**TOWN OF HERNDON, VIRGINIA
PLANNING COMMISSION PUBLIC HEARING AGENDA
FEBRUARY 25, 2019
HERNDON COUNCIL CHAMBERS BUILDING
765 LYNN STREET
7:00 P.M.**

Subject: Development Plan Application, DP#17-01, 555 Herndon Parkway

This memo serves as an addendum to the Planning Commission staff report, dated February 11, 2019, which was considered by the Planning Commission in its review of the above referenced case at its February 11, 2019 work session. The applicant has since submitted revised application materials to address the issues raised by staff and the Planning Commission.

POTENTIAL
ALTERNATIVE
PARKING PLAN

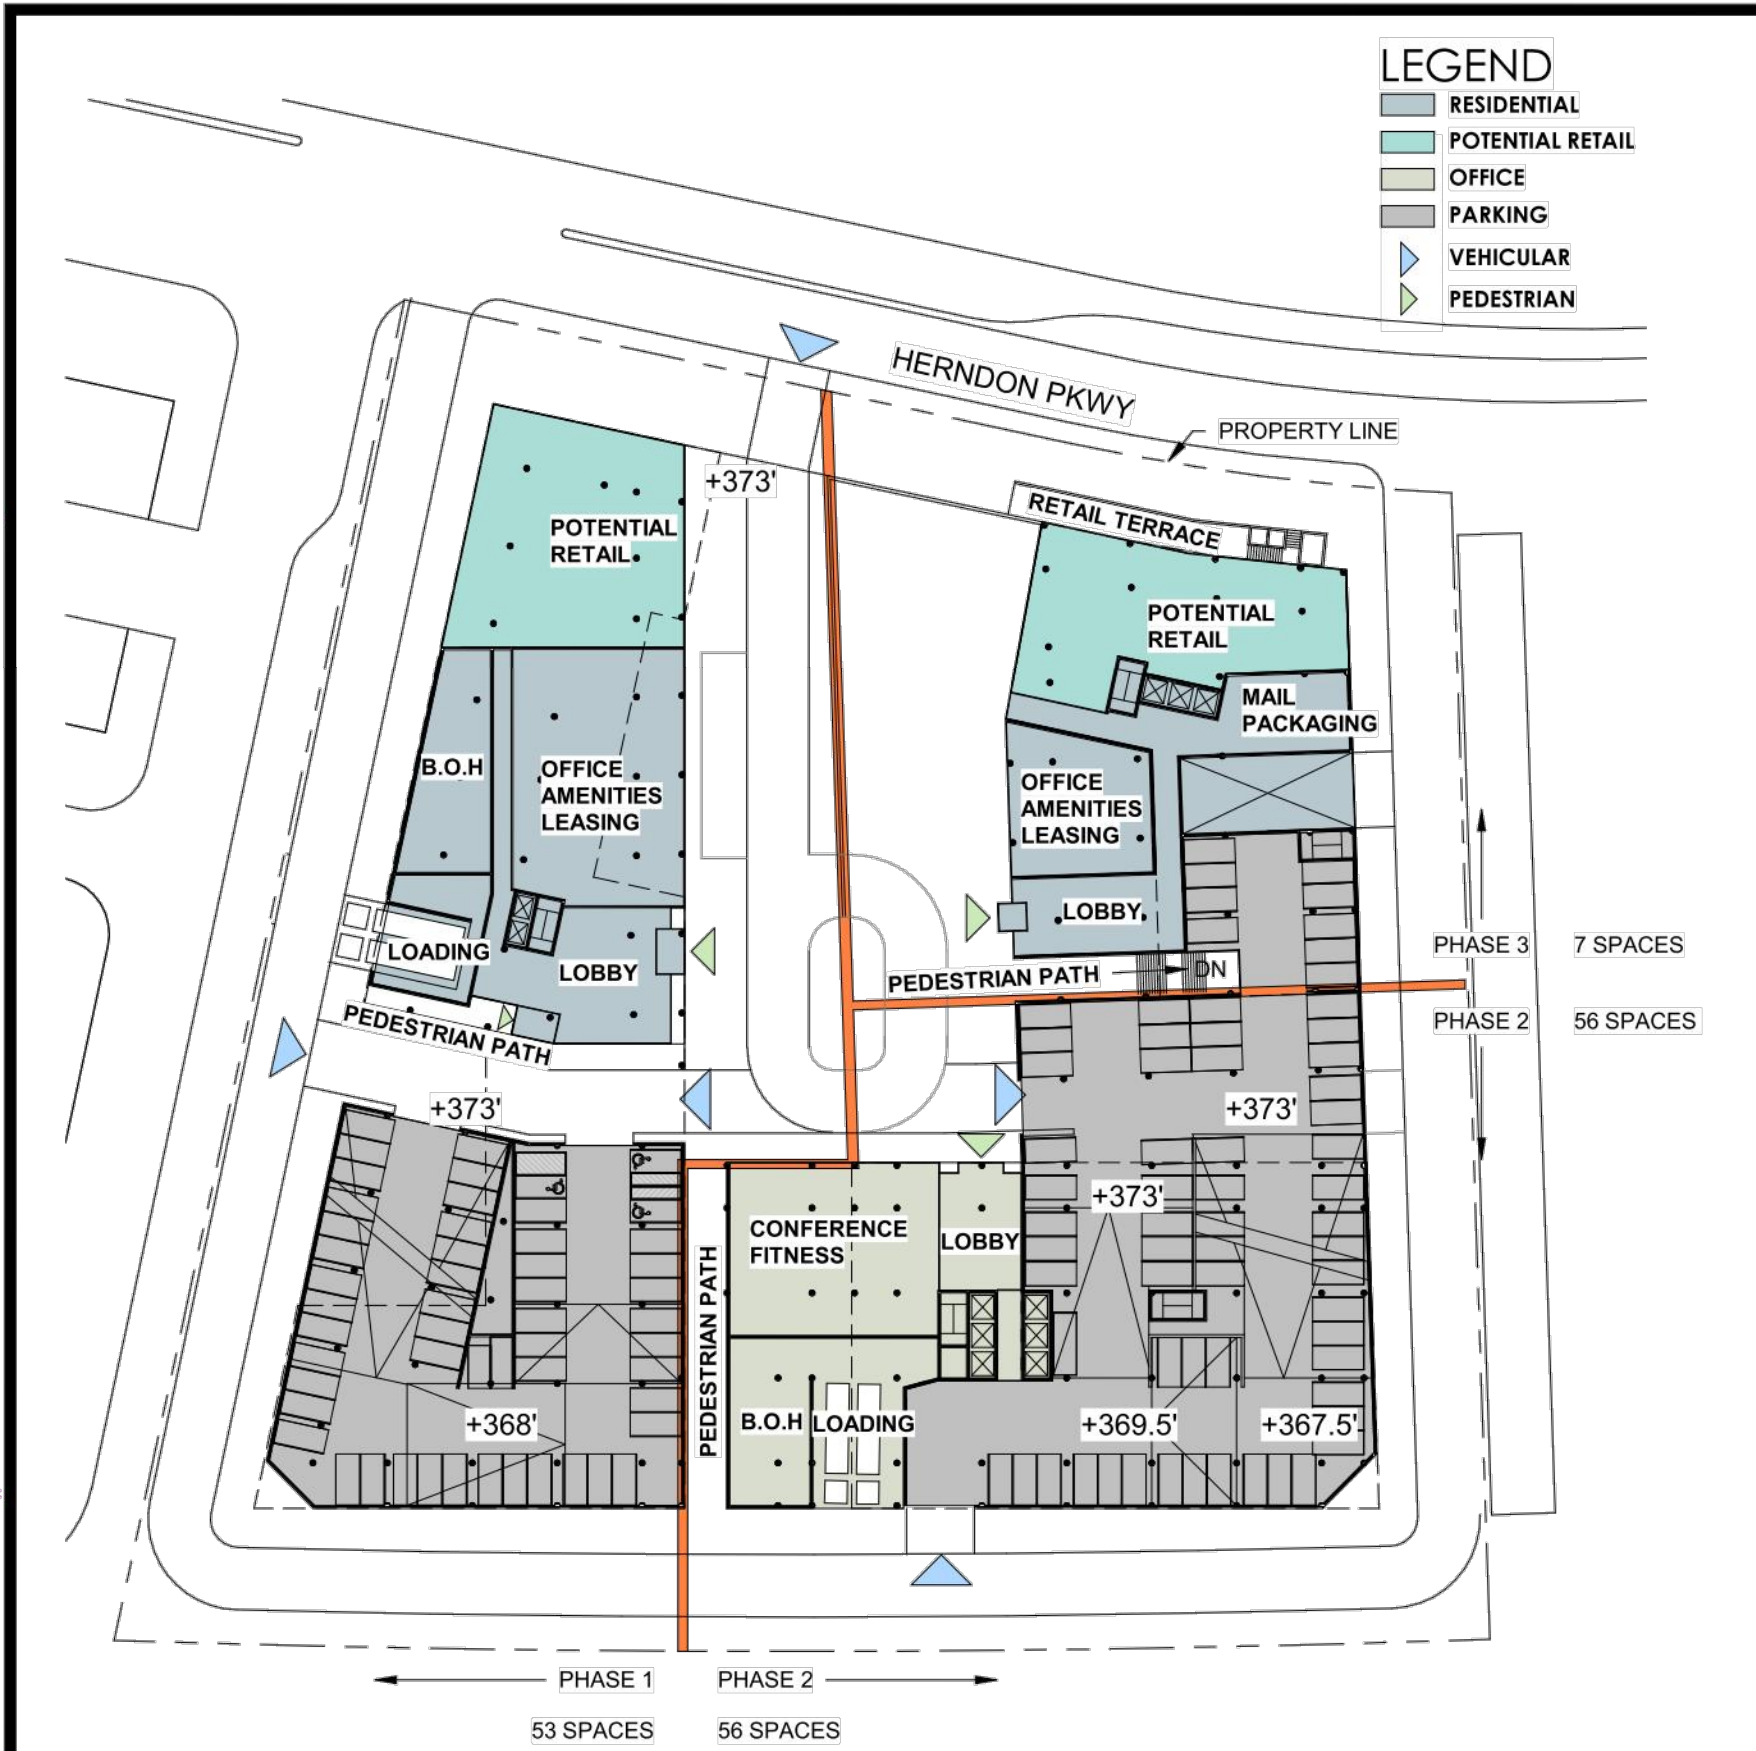
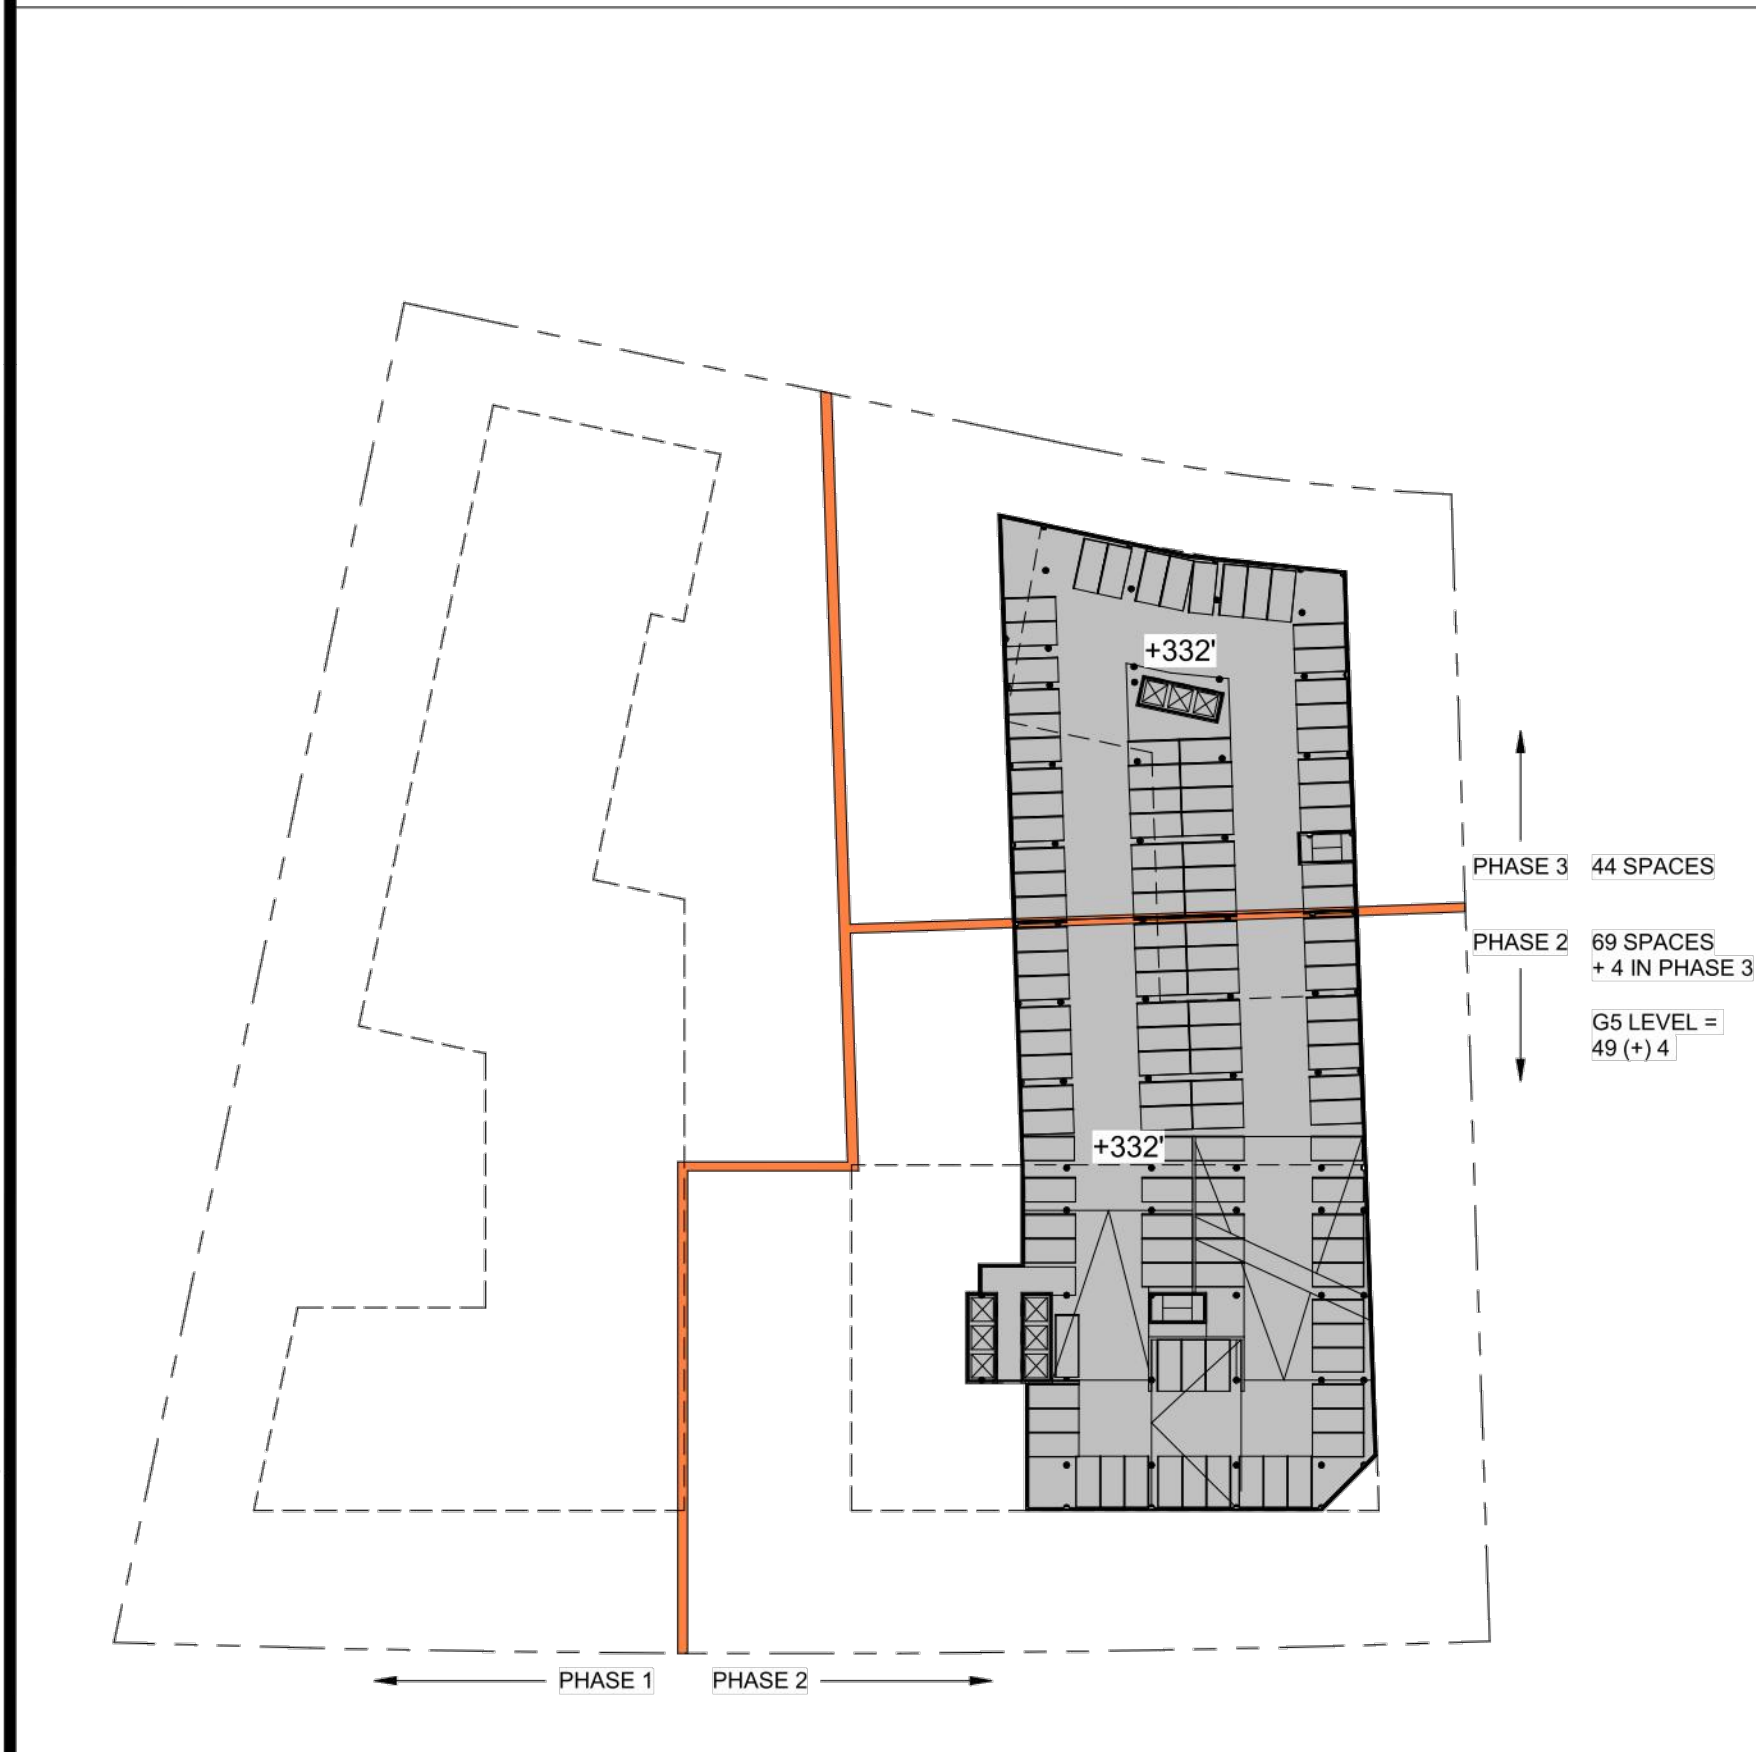
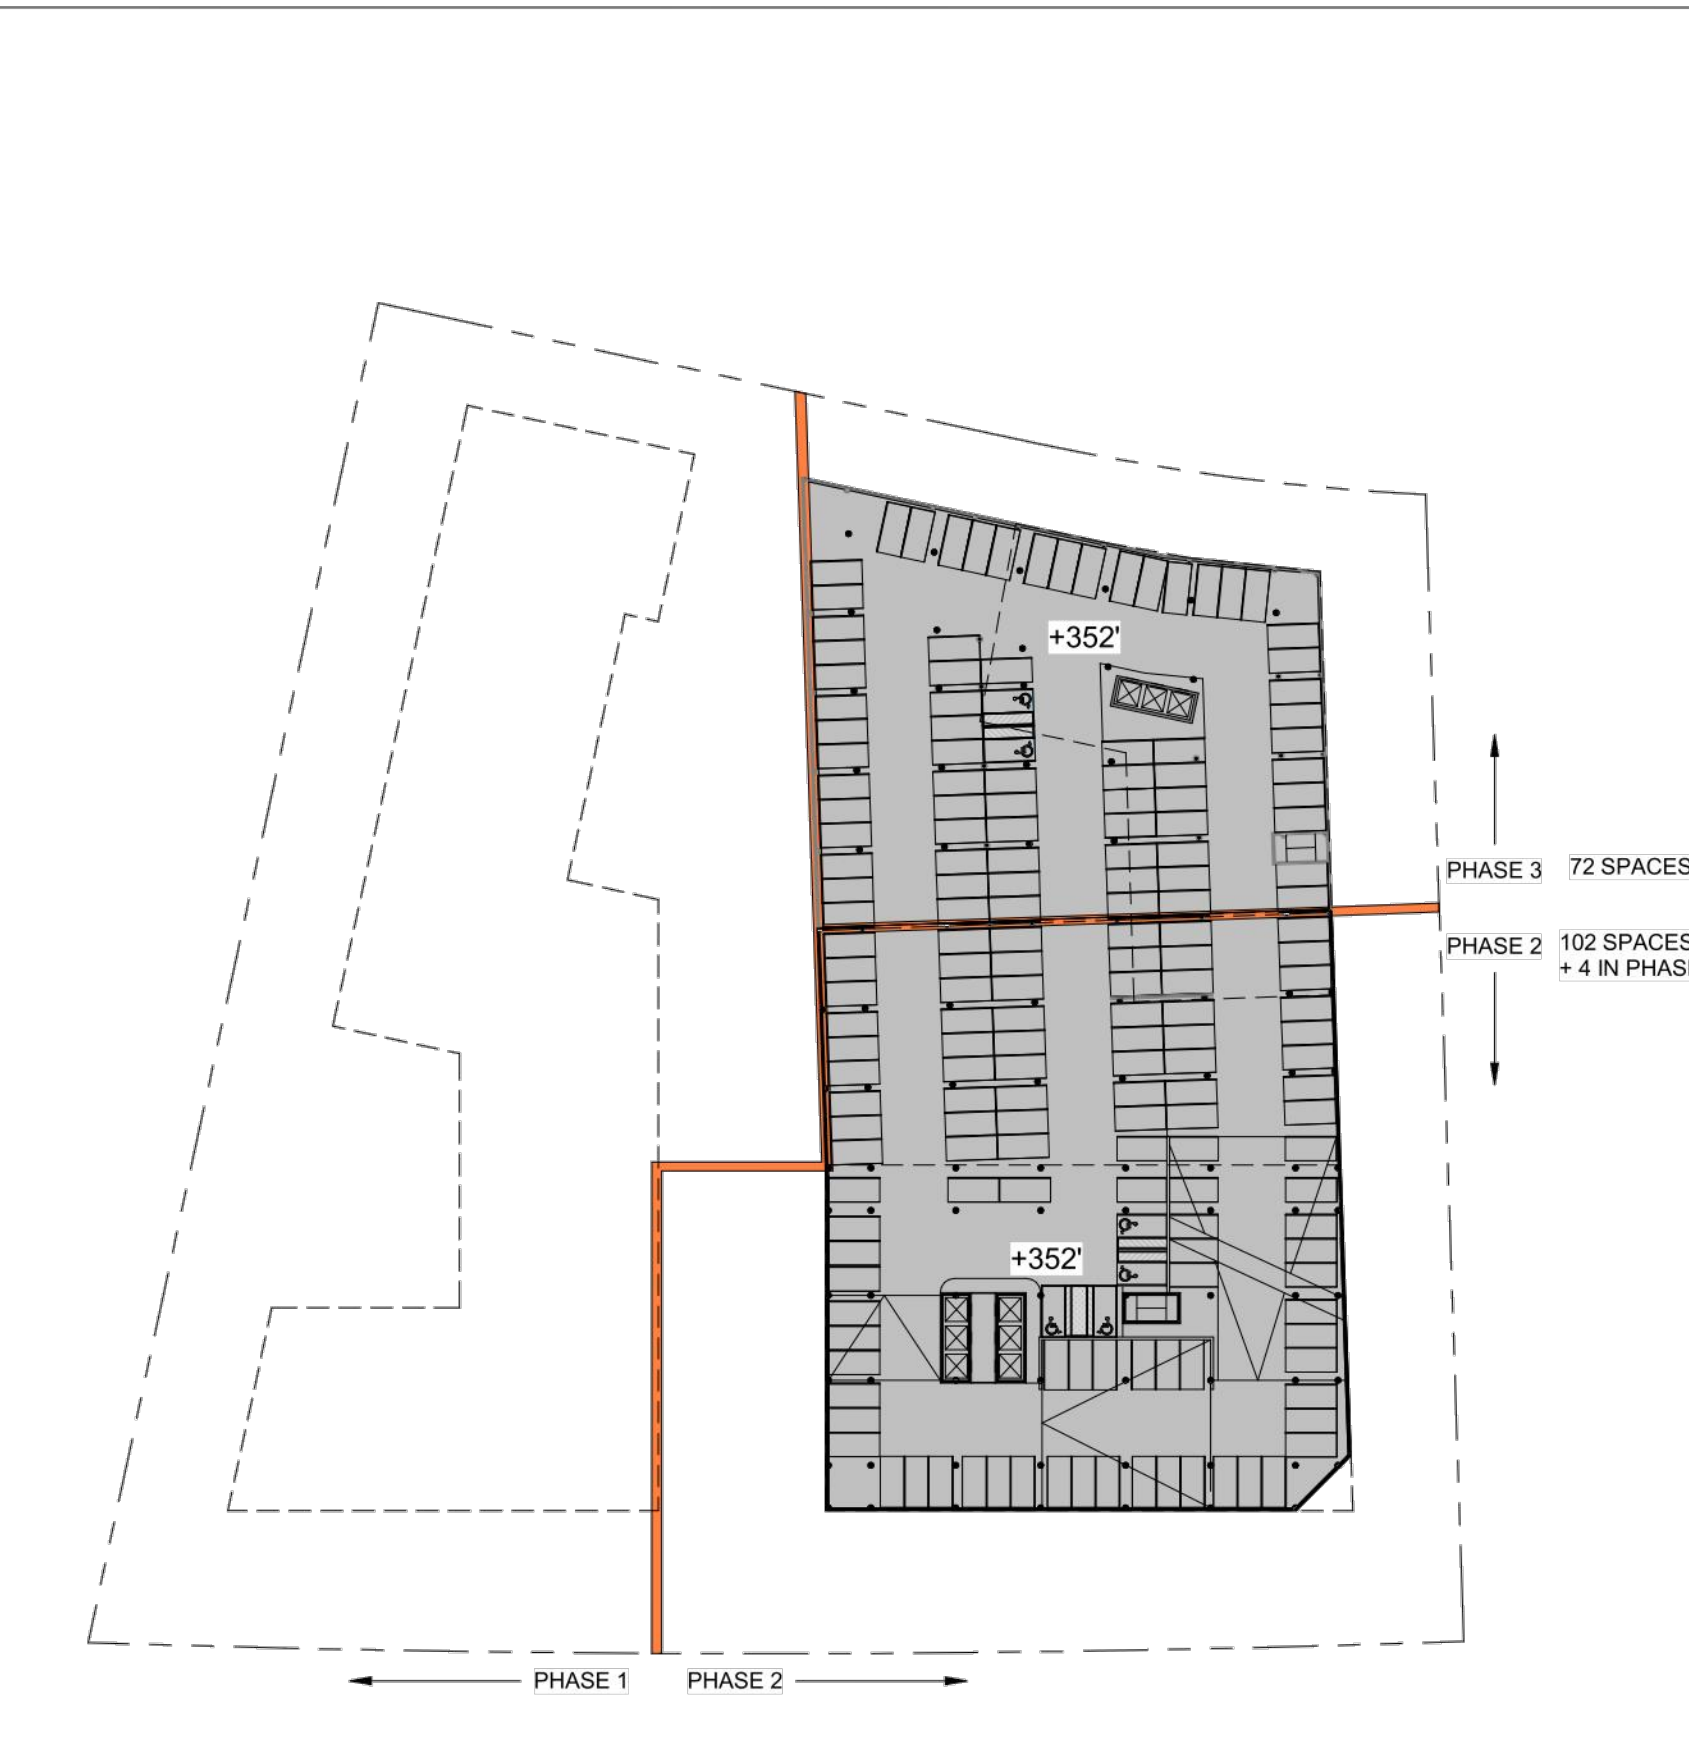
- Seating areas along sidewalks
- The alternative parking plan shows additional residential units and amenity space on level P3 (Sheet 14.1).
- Building elevation drawings have been included (Sheet 16.3).
